PLANNING COMMISSION AGENDA

Monday, March 31, 2014
Breckenridge Council Chambers
150 Ski Hill Road

Subject: Cabin Coffee Change of Use from Retail to Deli Space
(Class C Minor; PC#2014018)

- Subject:** Beaver Run Elevator and Airlock Addition, and Master Plan Amendment
(Class B Major Combined Hearing; PC# 2014008)
- Applicant/Owner:** Beaver Run HOA

Main Floor Plan 1692 sf

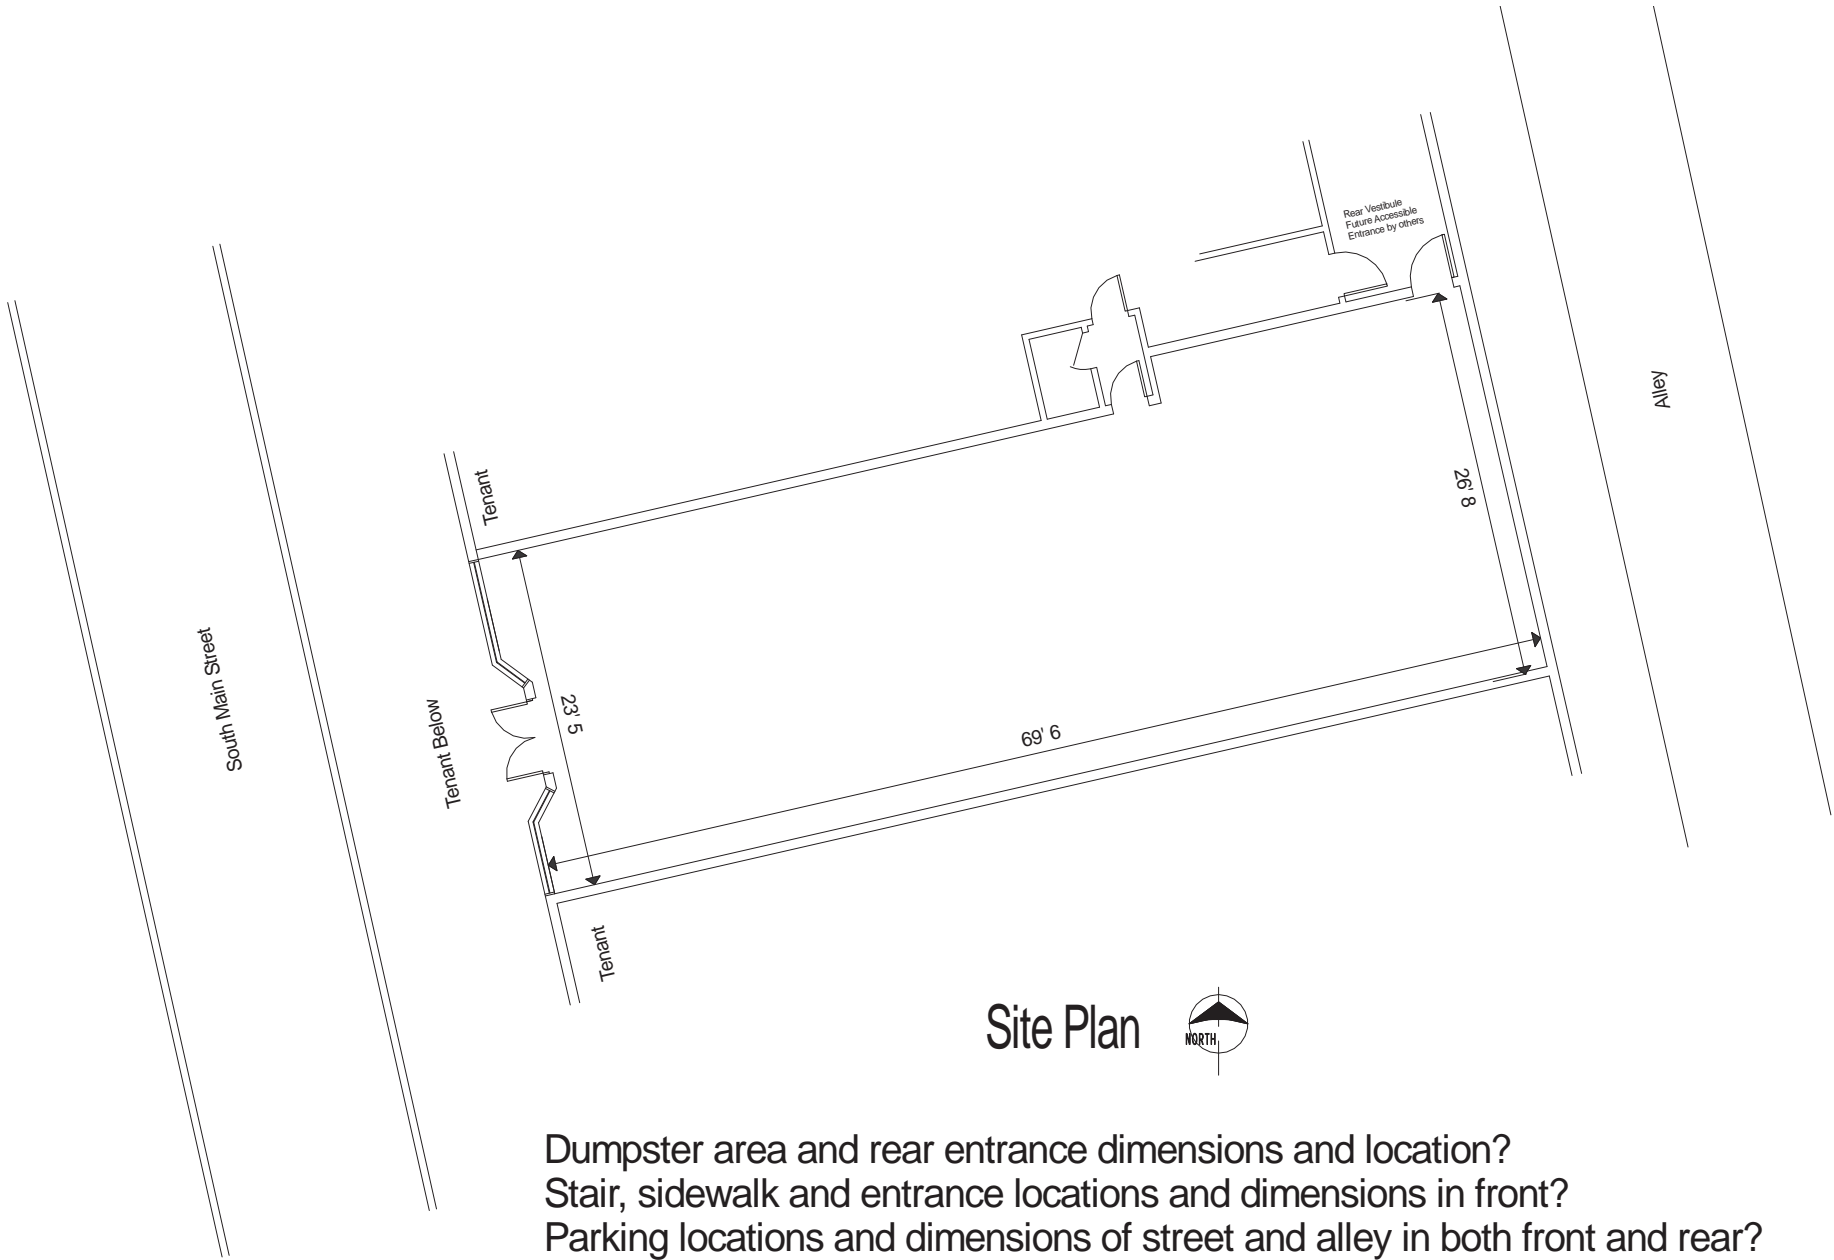
Dumpster area and rear entrance dimensions and location?
 Stair, sidewalk and entrance locations and dimensions in front?
 Parking locations and dimensions of street and alley in both front and rear?
